# PREVOST

**WB17-21**

DATE :	July 2017	SECTION :	06 ELECTRICAL
EXPIRATION:	July 2019		
SUBJECT :	<b>AE52-J2 GROUND MODIFICATION</b>

Figure 1

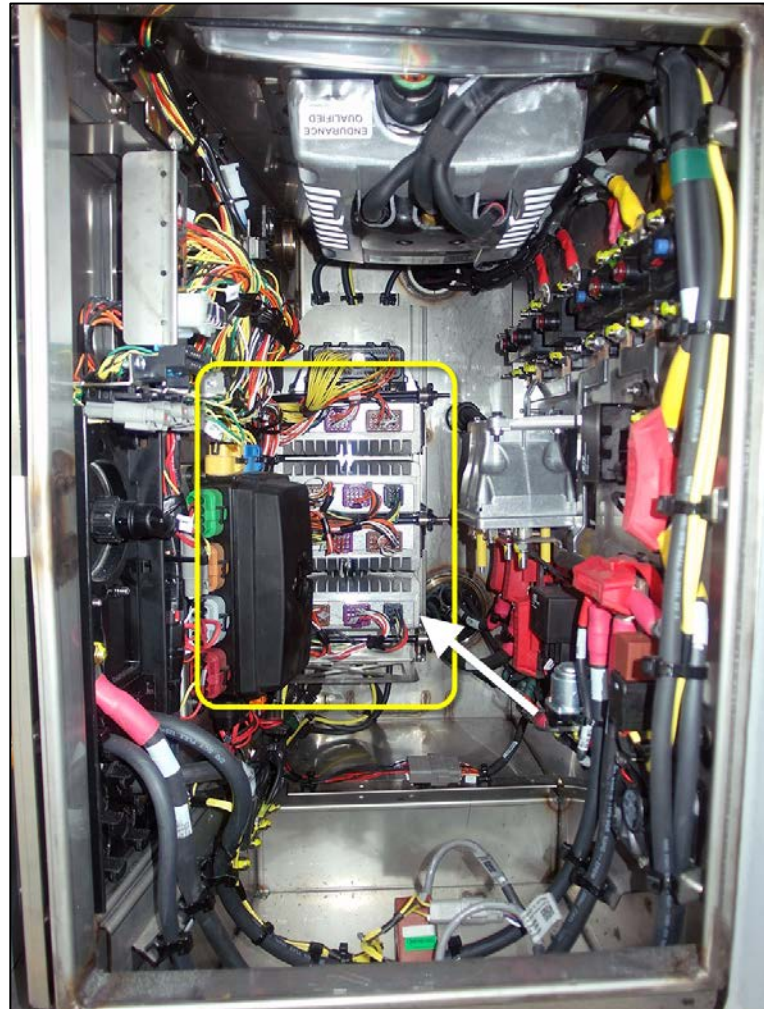
1. In the rear junction box, find module AE52. (Figure 1)

Figure 3

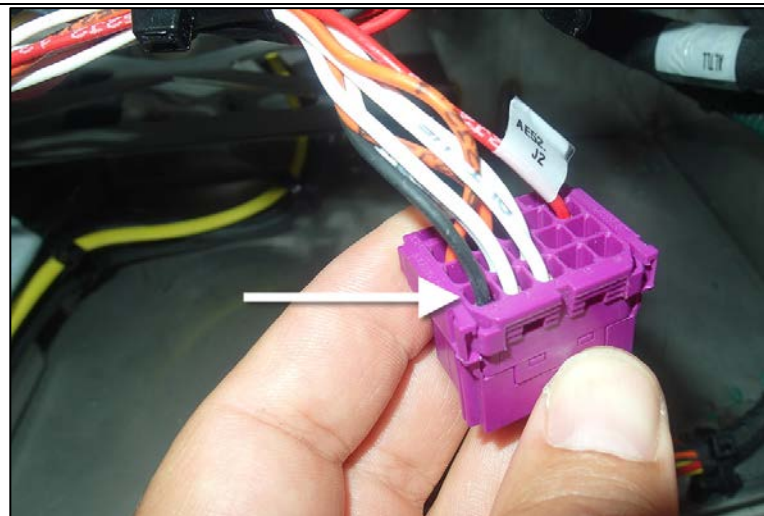
3. Remove black wire A52RJ2.3 from connector. (Figure 3).

Refer to *Prevost Maintenance Manual PA1621* [section 06b](#) paragraph **2.12** for the proper method of removing and restoring the secondary lock.

Use 568103 extractor (AMP 1579007-1)
